SUNDRY NOTICES AND REPORTS ON WELLS

8. Well Name and No. KUDU 9 FEDERAL/04

Well Name: Kudu 9 Fed 4 PROPOSED

Permanent Abandonment of Federal Wells
Conditions of Approval (LPC Habitat)

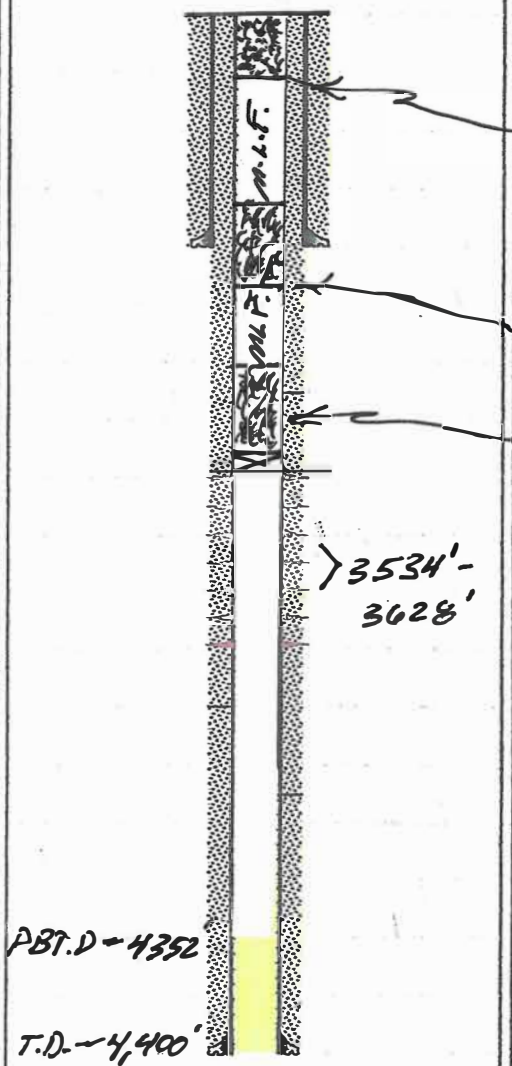
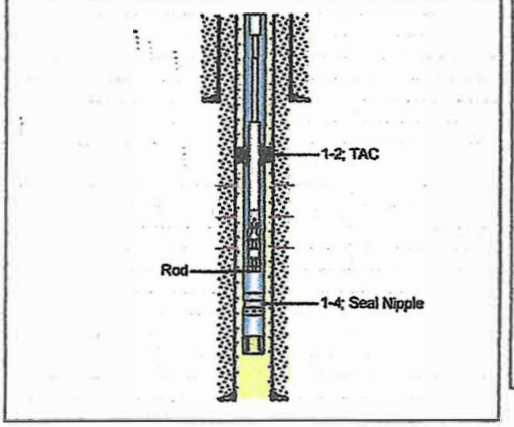
Plug Type	Top	Bottom	Length	Tag	Notes
Surface Plug	0.00	150.00	150.00	Verify circulated to surface	
Shoe Plug	1300.00	1850.00	550.00	WOC and	
Top of Salt @ 1800	1300.00	1850.00	550.00	WOC and Tag	
Yates @ 3320	3100.00	3484.00	384.00	WOC and Tag	500psi leak test at least 25 sks cement
CIBP Plug	3100.00	3484.00	384.00	WOC and Tag

No more than 2000' is to be allowed between plugs in open hole, and no more than 3000' between plugs in cased hole.
Class H >7500'
Class C<7500'
Fluid used to mix the cement in R111P shall be saturated with the salts common to the section penetrated, and in suitable proportions, but not more than 3% calcium chloride by weight of cement will be considered the desired mixture whenever possible.
Critical, High Cave Karst: Cave Karst depth to surface
R111P: Solid plug in all annuli - 50' from bottom of salt to surface.

Onshore Order 2.III.G Drilling Abandonment Requirements: "All formations bearing usable-quality water, oil, gas, or geothermal resources, and/or a prospectively valuable deposit of minerals shall be protected.

1) SET 4-1/2" CIBP @ 3,484'; CIRC. WELL W/ M.L.F.; PRES. TEST 30mins 4-1/2" CIBP X CSG. TO 500# X HOLD; PUMP (50) SXS. CLASS "C" CMT. @ 3,484 '-3,100' (T/YATES, B/SALT); WOC X TAG TOC.

2) PUMP (40) SXS. CLASS "C" CMT. @ 1,850'-1,300' (8-5/8" CSG.SHOE, B/SALT); WOC X TAG TOC.

3) MIX X CIRC. (15) SXS. CLASS "C" CMT. @ 150'-0'. VERIFY CIRCULATED TO SURFACE
